COUNTY OF SAN MATEO
Inter-Departmental Correspondence
Planning and Building Department

SUBJECT: Public hearing to consider a design review permit, pursuant to Section 6565.3 of the County Zoning Regulations, to construct a new 4,155 sq. ft. single-family residence and the removal of five (5) trees, and a grading permit, pursuant to Section 8600 of the County Ordinance Code, for 755 cubic yards of cut and fill for the Farahyar project located at 726 Bayview Way in the unincorporated Emerald Lake Hills area of San Mateo County (appeal of the Planning Commission's decision/Community Development Director's approval of the project).

County File Number: PLN 2009-00332 (Farahyar)

DIAGRAM #3

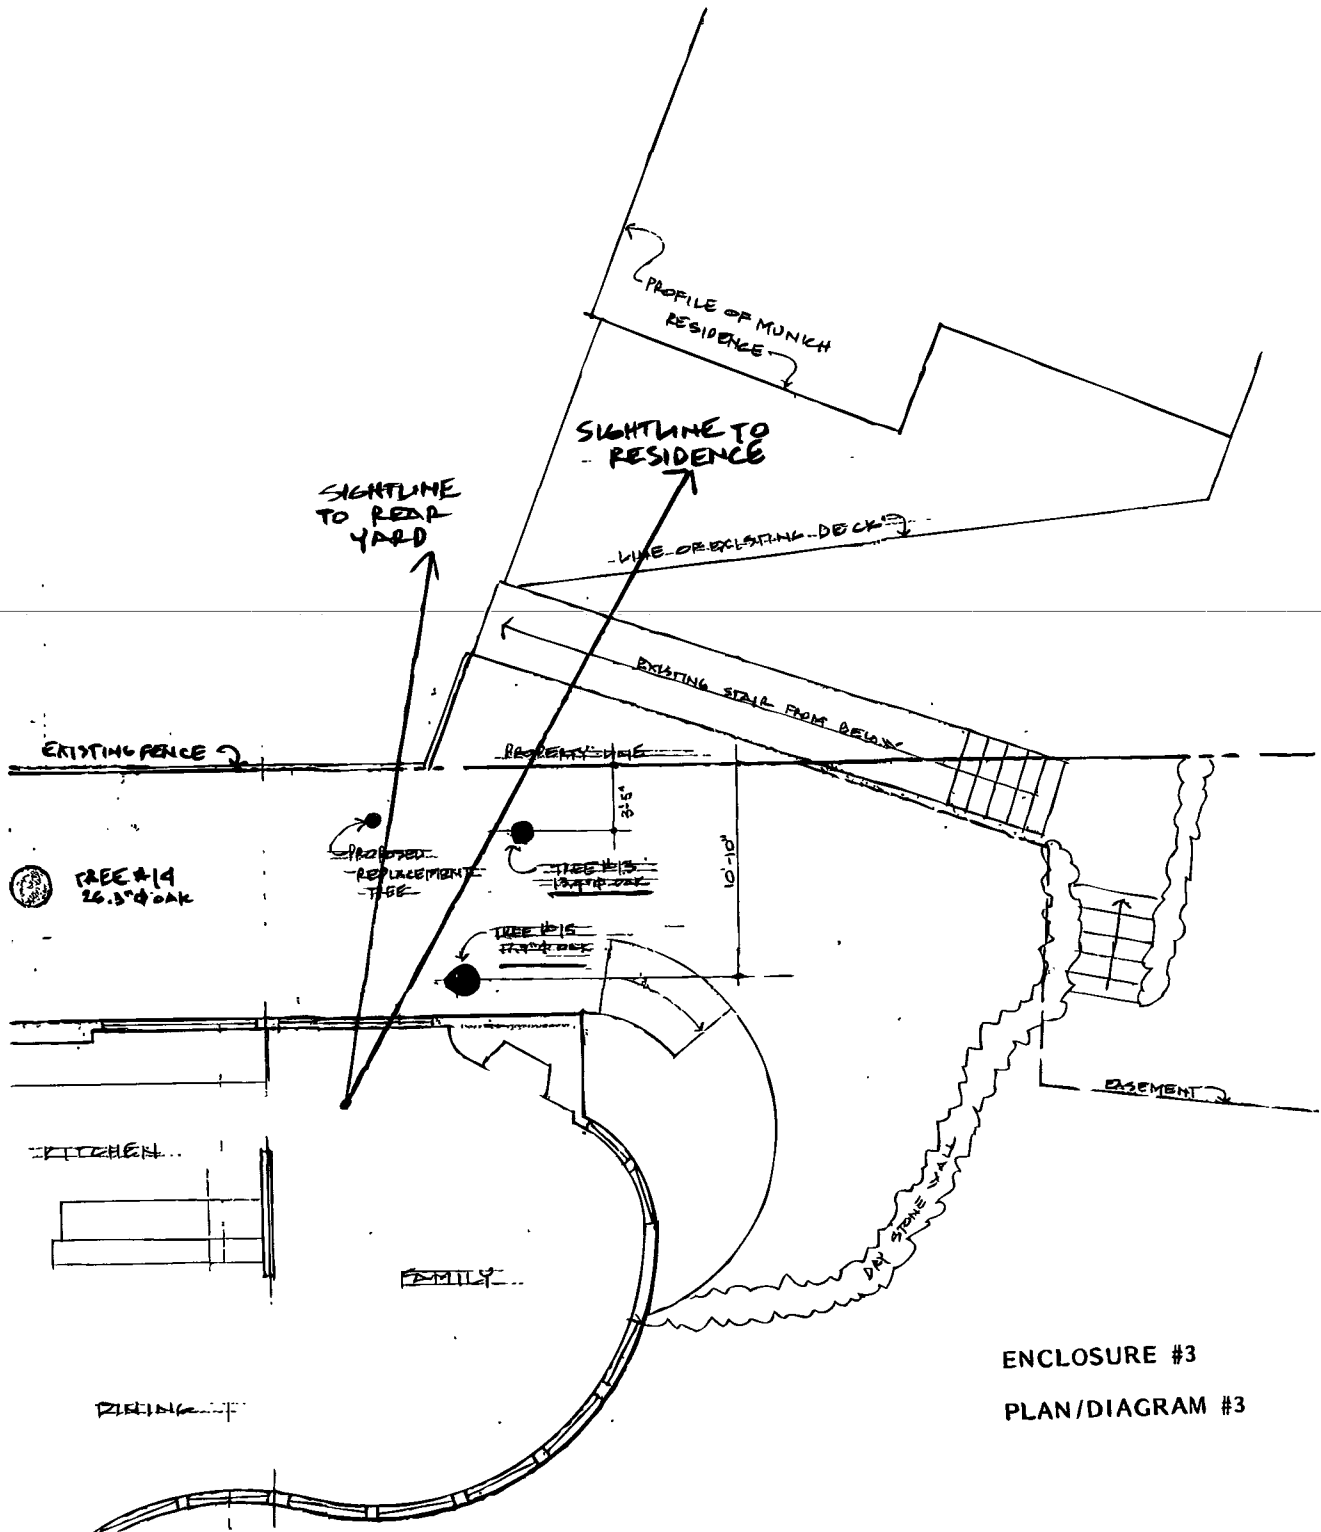
DUPLICATION OF SCREENING BY TREES #13 & #15

DIAGRAM #8 LOCATION OF PROPOSED TRELLIS SCREEN

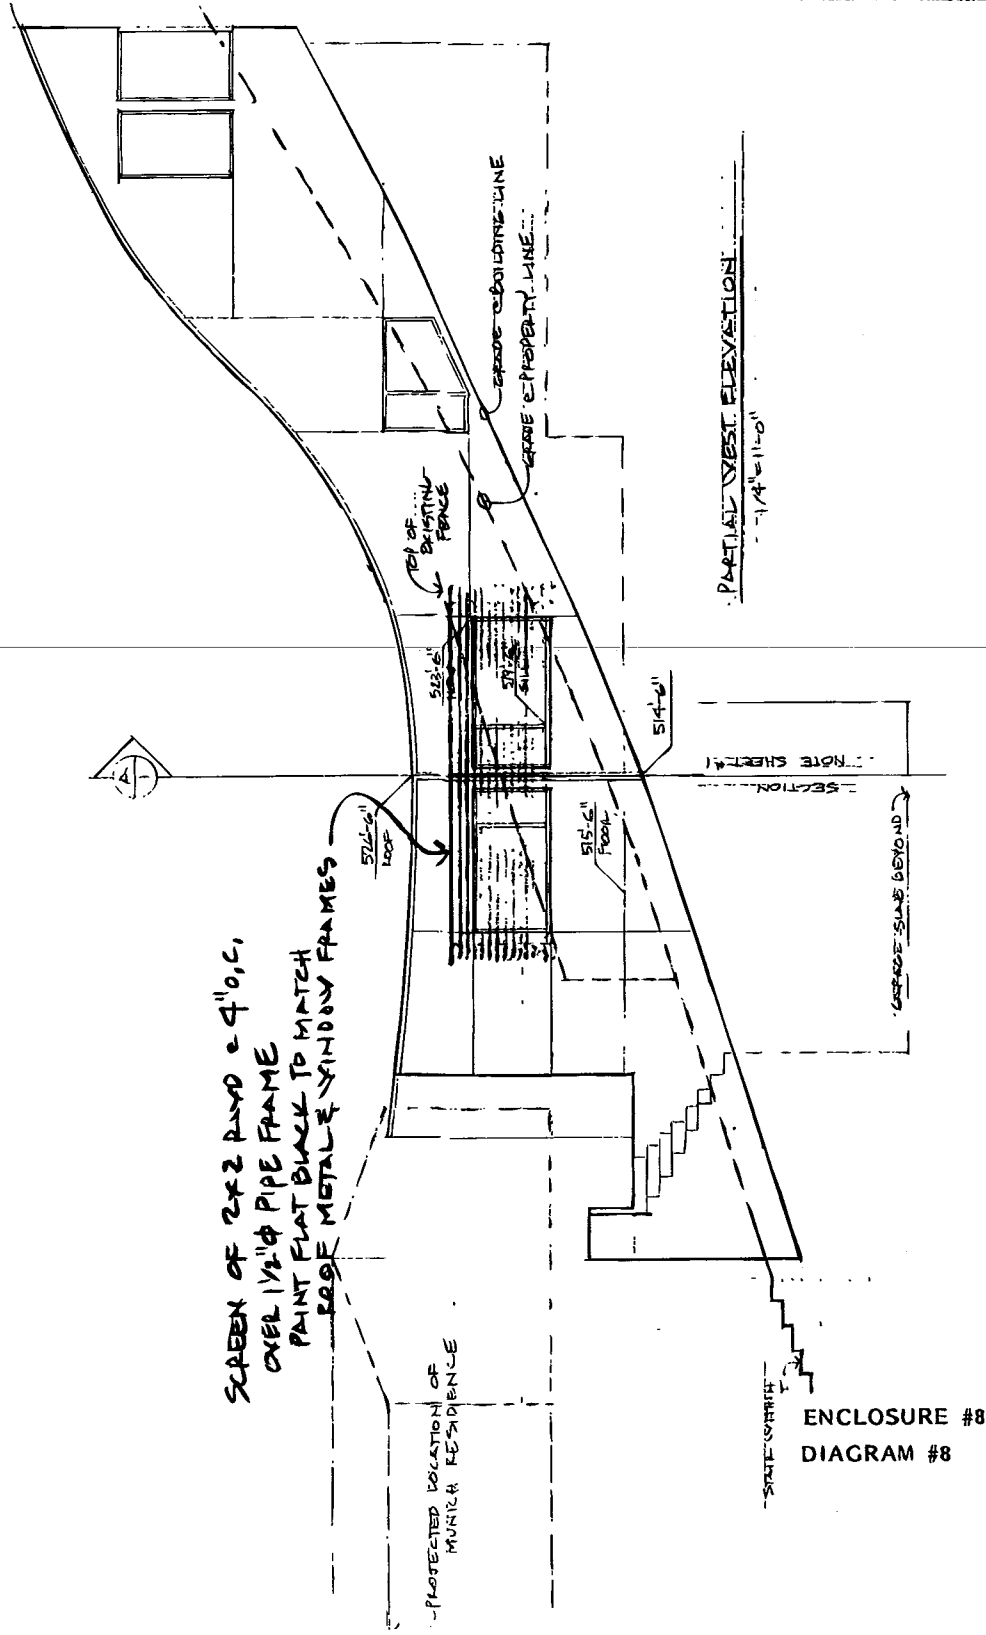
3. Enclosed photo #5 illustrates the view from the midpoint (in plan) of the two windows Mr. Munich believes will intrude on his privacy. This is exactly where replacement trees were proposed and approved (see diagram #6). Even more complete screening could be provided were Mr. Munich to allow plantings within his (now tree-free) sideyard. In this connection it should be noted that were the Munich and Farahyar home not well offset in plan, the many Munich residence windows which face the Farahyar property would pose genuine privacy issues! Note photo #7!

DIAGRAM #9

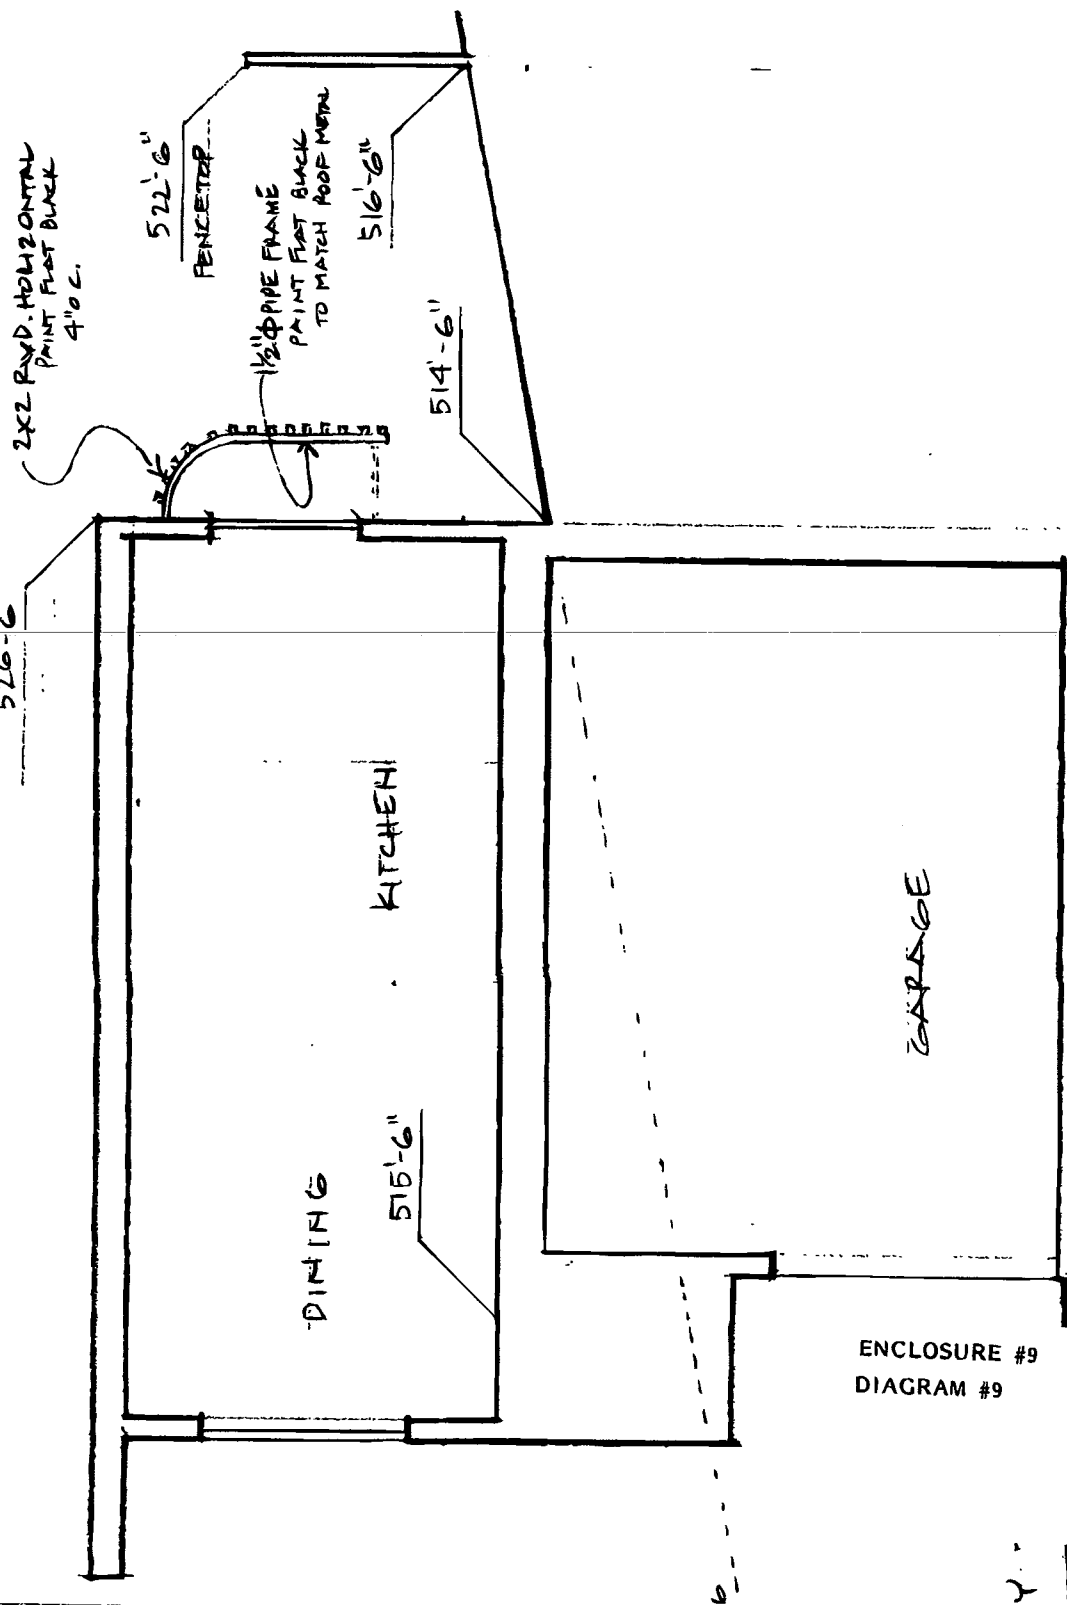
CROSS SECTION w/ TRELLIS SCREEN 526'-6"
